Answers to Reviewer #1:

This manuscript describes the procedures used to create and validate V3.1 of the BEC Arctic surface salinity product: Arctic+ SMOS SSS v3.1. The description is reasonably complete and well written. The following comments are offered in the spirit of improving the description:

Figure 19: Correction to be applied to measured half first Stokes parameter in 4 difference FOV positions for ascending passes (equation 20)

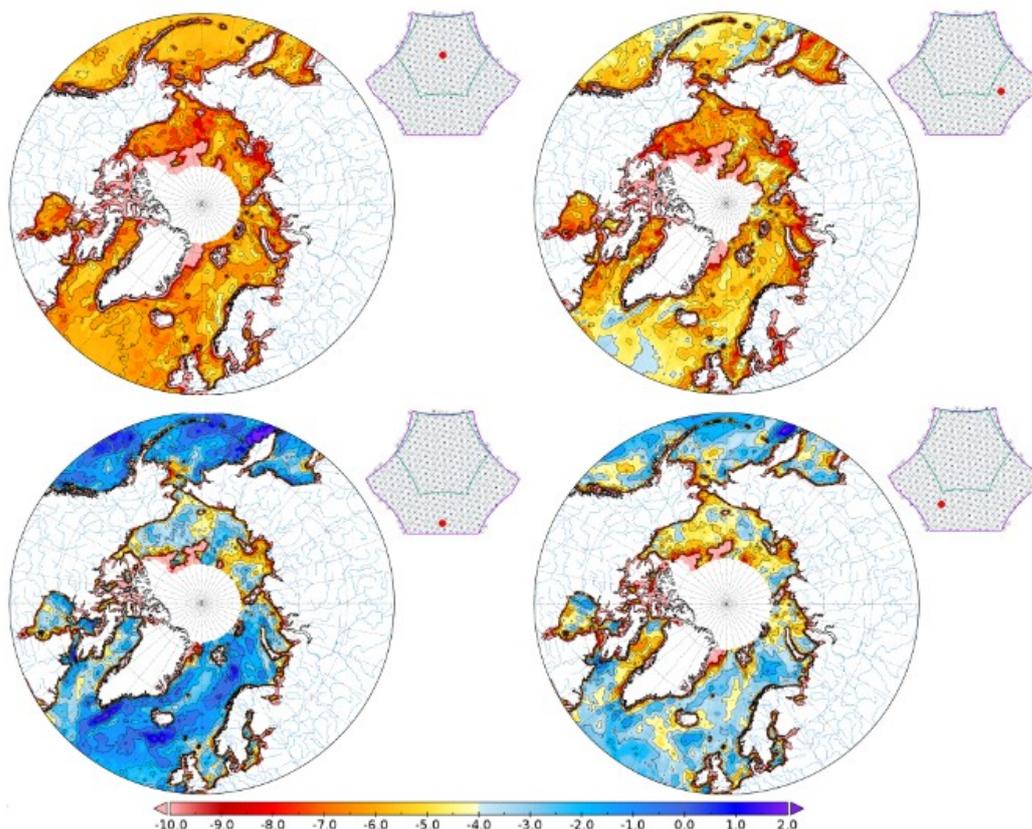
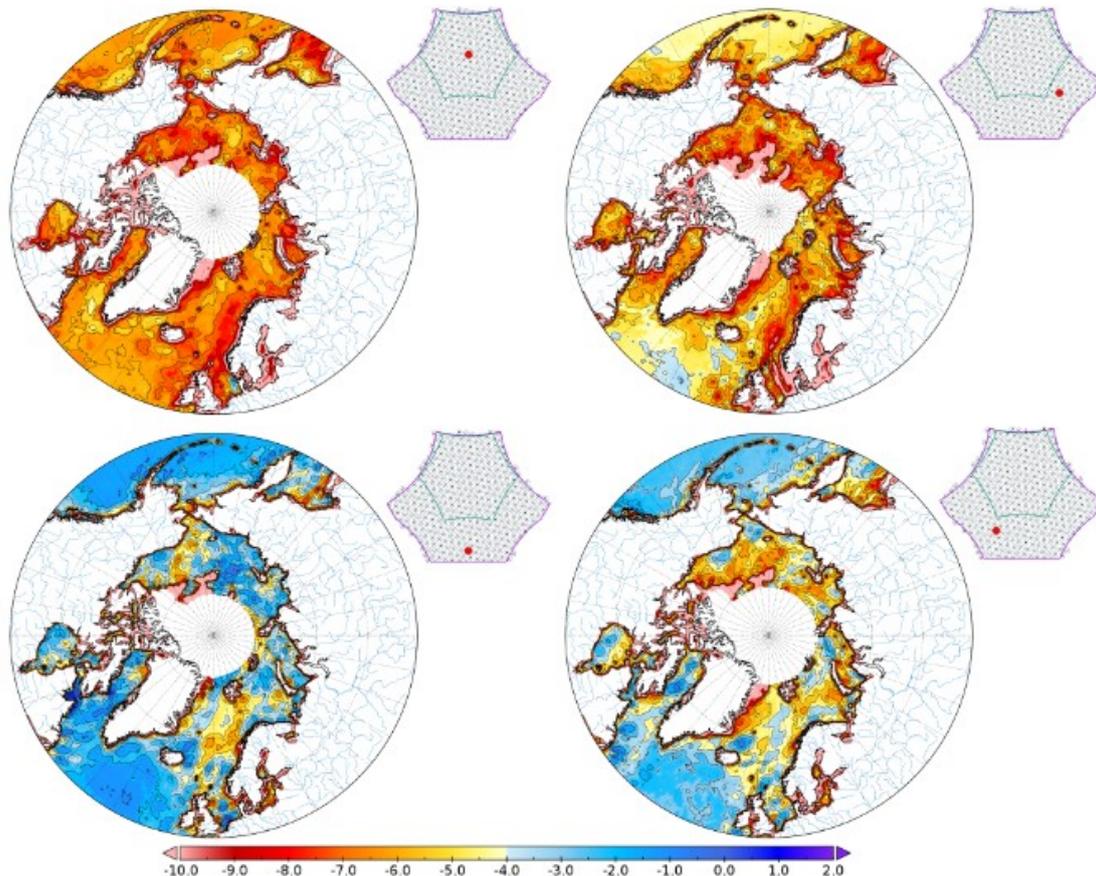
-Line 133-135: if I understood correctly you use, as reference, the SSS value obtained from the WOA instead to the one obtained from SMOS (average value). If so, which is the estimated differences between these values? Could you provide an example for some specific regions where the coast contamination is /or isn't relevant?

In this new version of the Arctic salinity product, the bias is corrected in TB and not in SSS. In this case the reference is the TB obtained from SSS and SST from WOA. The reference TB is computed from WOA SSS and SST using the Meissner and Wentz dielectric model. Then, we obtain TB values for each latitude, longitude, satellite orientation and position in the antenna reference frame (the new reference). The correction depends of a wide variety of factors but can attain values as high as 10K depending on the position in the antenna reference frame or the distance to the coast. Figures 19 and 20 from ATBD document (<http://dx.doi.org/10.13140/RG.2.2.12195.58401>) show the differences for 4 points of the field of view for ascending and descending cases (reproduced here)

Figure 28: Weighted average of all ascending L2B orbits in the period 2013-2019 minus WOA18-A5B7

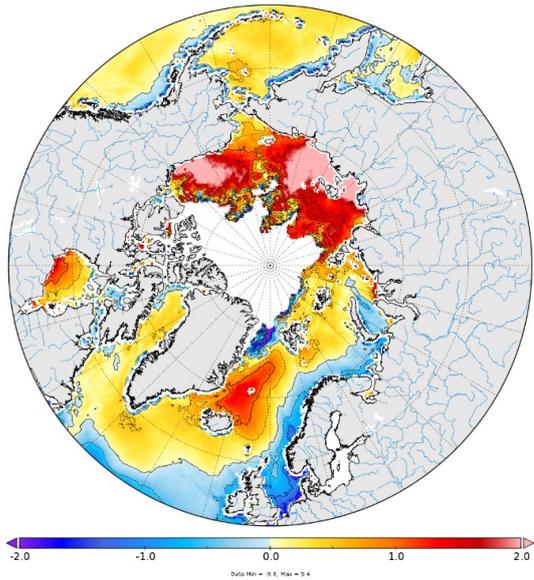
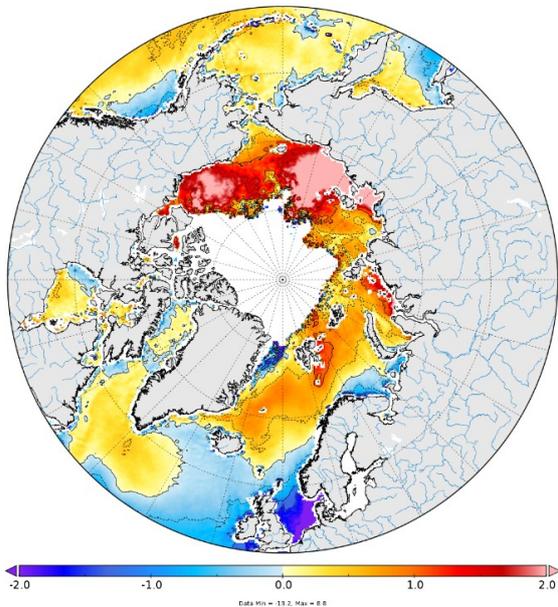
-line 276: how much the number differs from zero? This could be a useful information for the reader.

The weighted average of all L2B orbits in the 2013-2019 period minus the value provided by WOA ranges between -10 and 10 psu but mainly between -2 and 2 psu. The values differ a lot between the Arctic zones being smaller in the open ocean and larger in the North Sea (negative), in the Beaufort Sea (positive) and the East Siberian Sea (positive) . [See following figures]

This information, not the figures, has been included in the text.
